ANNEX B-1. VALUE ENGINEERING REPORT

370939 CENTRAL EVERGLADES PLANNING PROJECT FEASIBILITY PHASE

VALUE ENGINEERING STUDY REPORT

February 2013
(Updated January 2014)

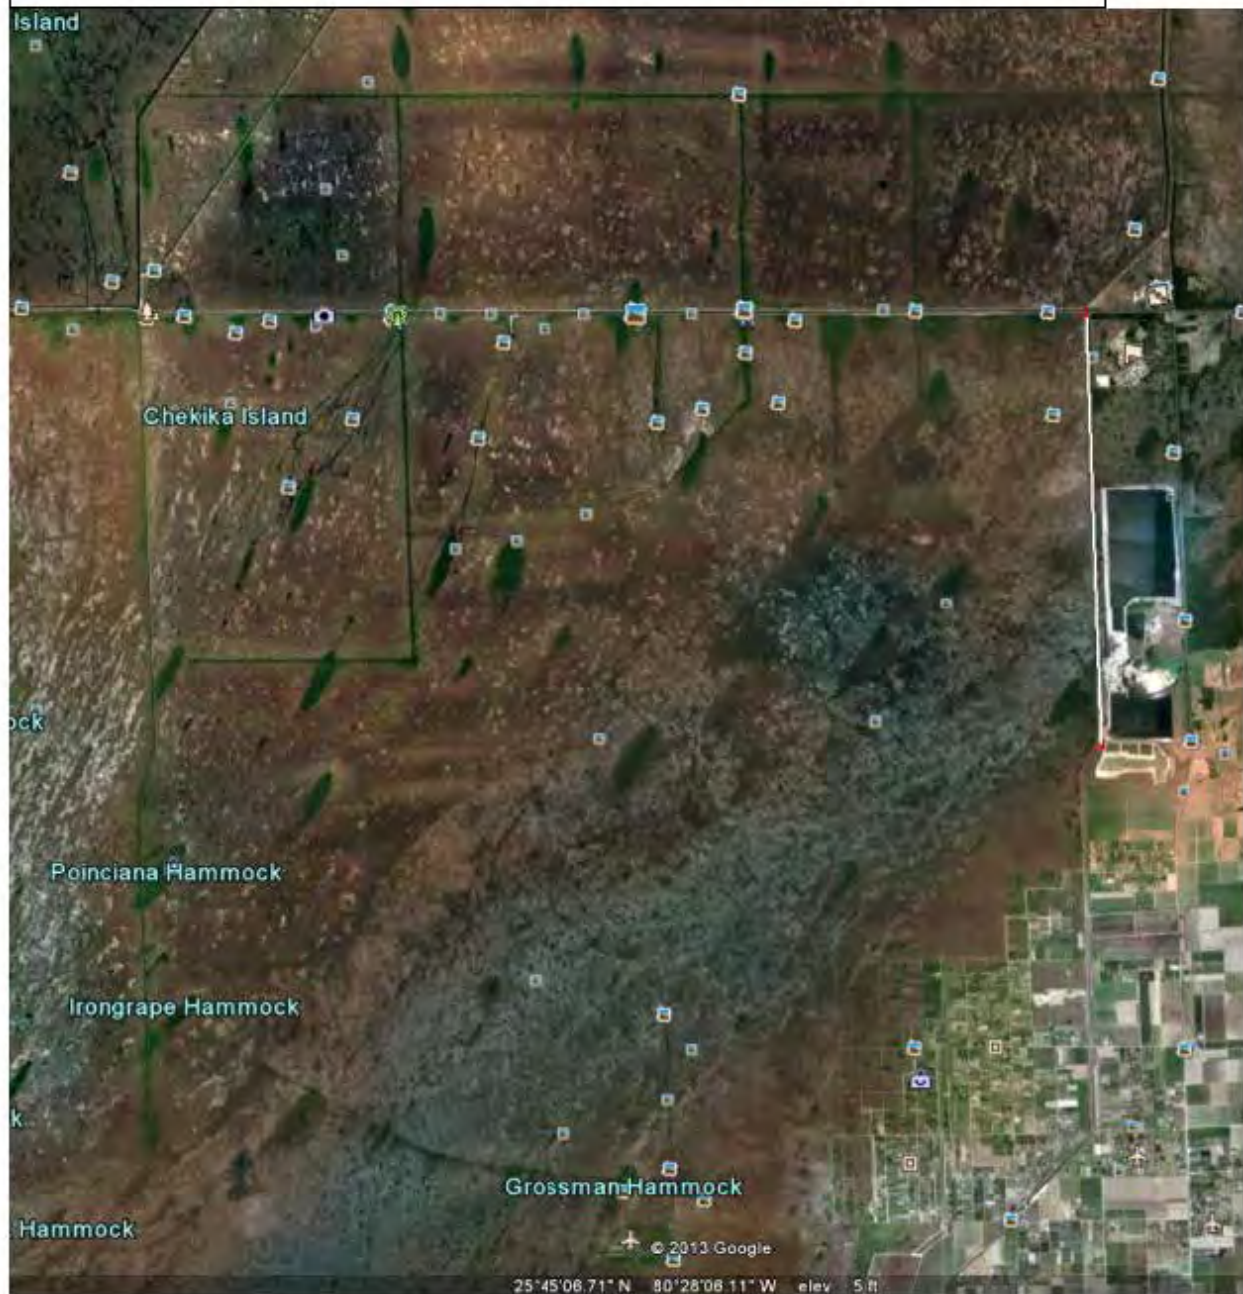
station currently planned at 1,000 cfs capacity. This option would call for the construction of the proposed adjacent canal seepage barrier cut-off wall and project purpose water level increase in the Everglades Park. The existing 500 cfs pump station will likely be capable of accommodating most if not all seepage flow and actual pumping needs can be measured (see above recommendation regarding station design flowrate determination – 750 cfs / 1,000 cfs). Note that initial hydration of the Park can be initially controlled until such that pump station capacity is not exceeded.

Implementation of extending service of the temporary station appears to be difficult. Difficulties include, but may not be limited to:

- Expiration of current federal authorization and funding for operation and maintenance
- Ownership and responsibility
- Current litigation regarding discharge water quality (issue for permanent station as well but this option would require faster resolution)
- Physical rehabilitation of the station to facilitate continued use

Given the potential cost savings and advancement of some project benefits that this option would produce, addressing the above issues appears to warrant consideration.

Preliminary disposition: Address recommendation in current plan development, project design phase and in development of the Adaptive Management Plan.

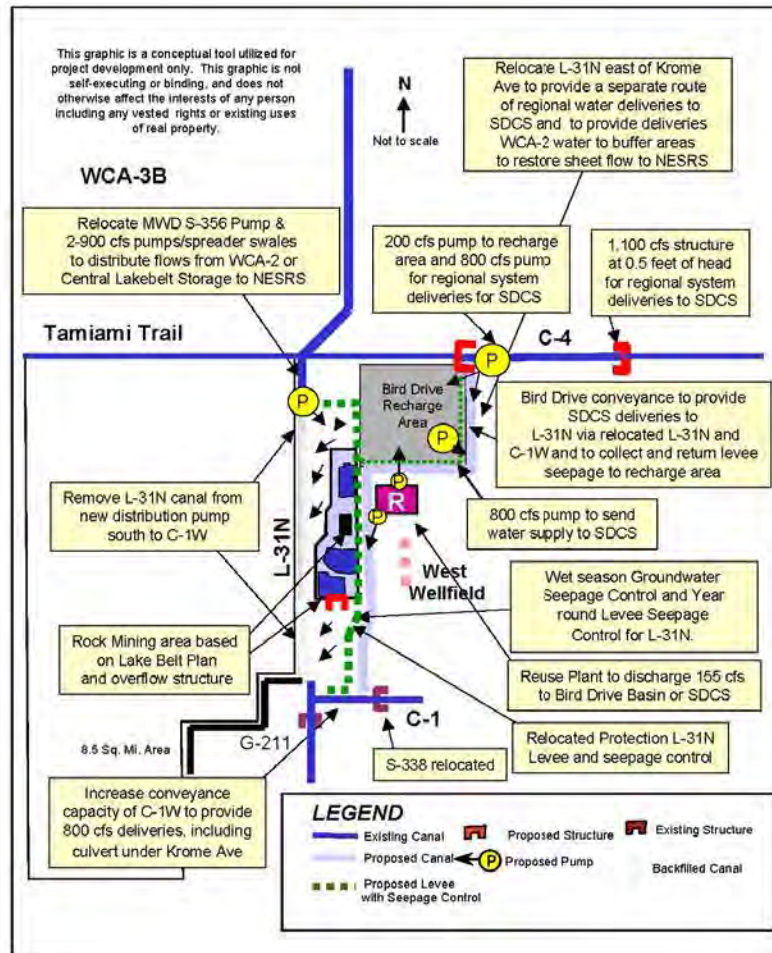
Y-5 Change the location L31N Seepage Management Pilot Project (SMPP) to the location which was the original location contained in the authorized decision document; use CEPP to increase the 902 Limit for L31N SMPP and install the L31N SMPP to remove project uncertainties - L-31N Seepage Management – Pilot Project is an authorized component in the Central and Southern Florida Project, Comprehensive Review Study, Final Integrated Feasibility Report and Programmatic Environmental Impact Statement.

This recommendation proposes that:

- The location of the pilot be returned to the original location as depicted on the below page excerpt from the study;
- CEPP be used to update the 902 limit for the pilot test and
- Implement the pilot test early in the project implementation phase to remove and define uncertainties.

Preliminary disposition: – *Not adopted. The PDT response changed from Address recommendation in current plan development in February 2013 Report to Not adopted in January 2014 to reflect subsequent report coordination. The L31 N SMPP was the pilot component of the original CERP L31N Improvements for Seepage Management. The CEPP PDT has decided to use the monitoring and results of a nearby constructed non-federal seepage project that was installed as described in main PIR sections 2.5.12 and 6.10.2.1 to address project uncertainties for CEPP.*

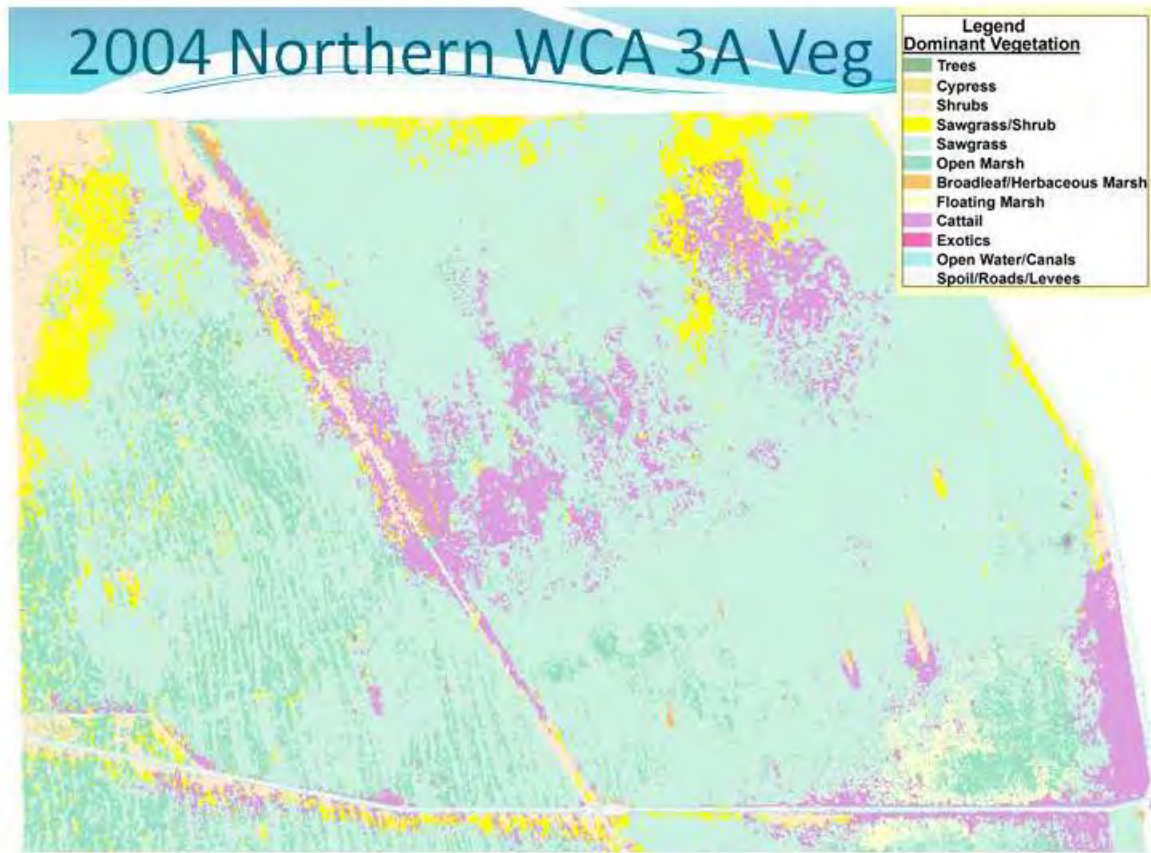
GC-2 Coordinate vegetation management to achieve multiple objectives - Much of the vegetation south of L-4 levee are upland species due to the drying out of Northern Water Conservation Area 3A (WCA 3A). These woody species are likely to persist and may require specific vegetation management activities to facilitate transition of the landscape to more wetland type vegetation (e.g., sawgrass). Cattail and Willow expansion may be an issue and needs to be properly managed to avoid further degradation and complication in achieving a ridge and slough landscape south of the L4 spreader canal, as well as getting water out of the canal for flood control needs due to flow resistant vegetation. In addition, vegetation management will likely be needed during construction of the L4 spreader canal to remove nuisance and exotic species, as well as potentially create vegetation pockets to help facilitate flow of water to aid recreation of sloughs upon entry into marsh. There are likely opportunities to strategically coordinate multiple vegetation management objectives (e.g., construction, nuisance, and restoration enhancement) to most cost effectively implement vegetation management activities.

Timing and nature of each vegetation management activity would need to be discussed and coordinated amongst engineering design, construction, exotics removal, and ecological/adaptive management subteam to determine what vegetation management efforts are needed when and how they can be best be implemented. The Invasive and Native Nuisance Species Management Plan (INNSMP) would address responsibilities and timing. The INNSMP is a living document. It would be updated/revised as surveys are done and treatment/removals conducted, and include proposed schedules of surveys. During O&M, the structures would be monitored by the responsible operations entity. Areas of claimed benefits outside of the structures would be monitored by the project (PLMP, RECOVER, or other). Close coordination among agencies would be required for such a program to succeed. Areas needed to be treated most times can be covered by existing services contracts that the USACE/SFWMD already has in place.

Preliminary disposition: Address recommendation in development of Adaptive Management Plan.
